PCN-20210216a TE0712-02 DDR3, Flash Change and Product Update (Revised)

Company	Trenz Electronic GmbH
PCN Number	PCN-20210216a
Title	TE0712-02 DDR3, Flash Change and Product Update
Subject	BOM change
Issue Date	(2021-02-17), Revised 2021-03-09

This change affects all Trenz Electronic TE0712 SoMs of revision 02: TE0712-02-*

#2 Replaced Flash (U4) to IS25LP512M-RHLE All SoMs use S25FL256SAGBHI20 Flash (U4)

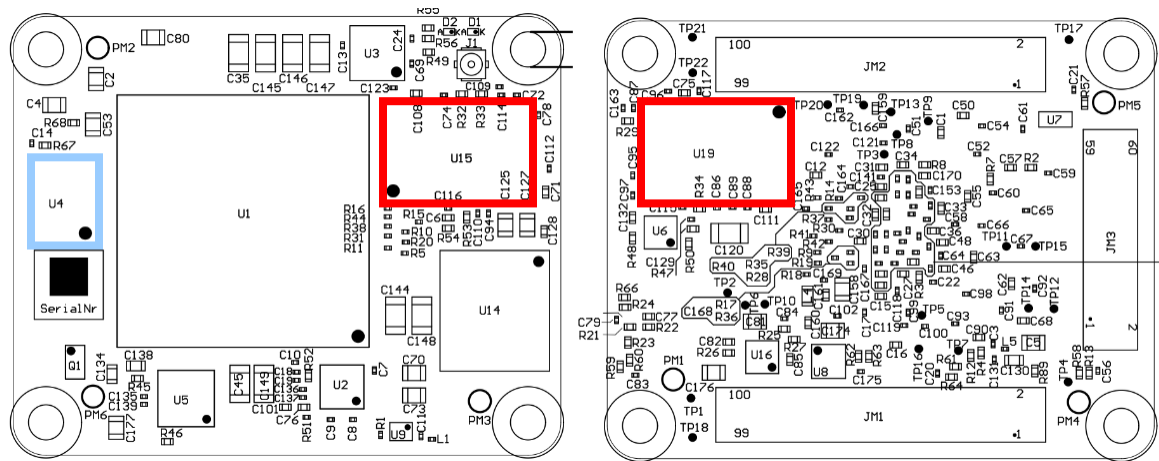
Type: BOM change
Reason: Ensure long time availability.
Impact: ~~Jedec Manufacturer ID changed from 01h to 9Dh, the device ID from 18h to 19h. 512Mbit flash are now available.~~

Type: BOM change
Reason: The planned IS25LP512M-RHLE is listed as 'Supported Flash Memory Devices for Artix-7 Device Configuration' in Xilinx UG908 (since version 2019.1), but there are unsolved problems with reboot after petalinux was started. Therefore this change is canceled. Only modules where other than S25FL256SAGBHI20 was used are changed to S25FL256SAGBHI20.
Impact: Jedec Manufacturer ID is 01h, the device ID 0219h. Size does not change, 256 Mbit flash are available.

Locate DDR3 RAM (U15 top, U19 bottom) and Flash (U4 top) on PCB:

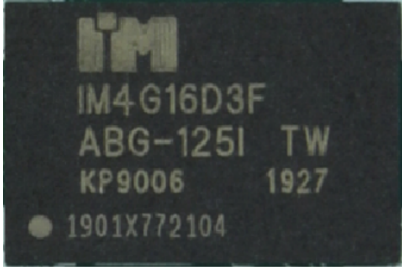
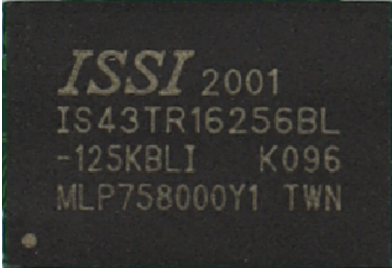
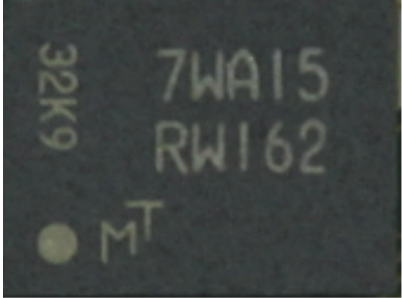
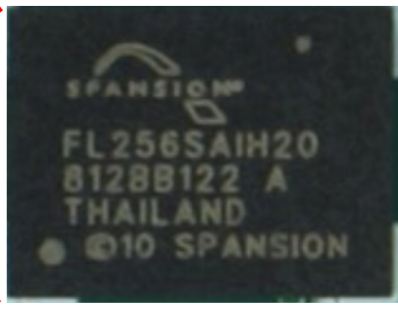
#1 Change DDR3 RAM (U15, U19) from IM4G16D3FABG-125I to IS43TR16256BL-125KBLI

old	new
-----	-----

IM4G16D3FABG-125I	IS43TR16256BL-125KBLI

S25FL256SAGBH120 or MT25QL256ABA8E12-1SIT	IS25LP512M-RHLE
 TE0712-02-2CA and TE0712-02-72C03-M only:
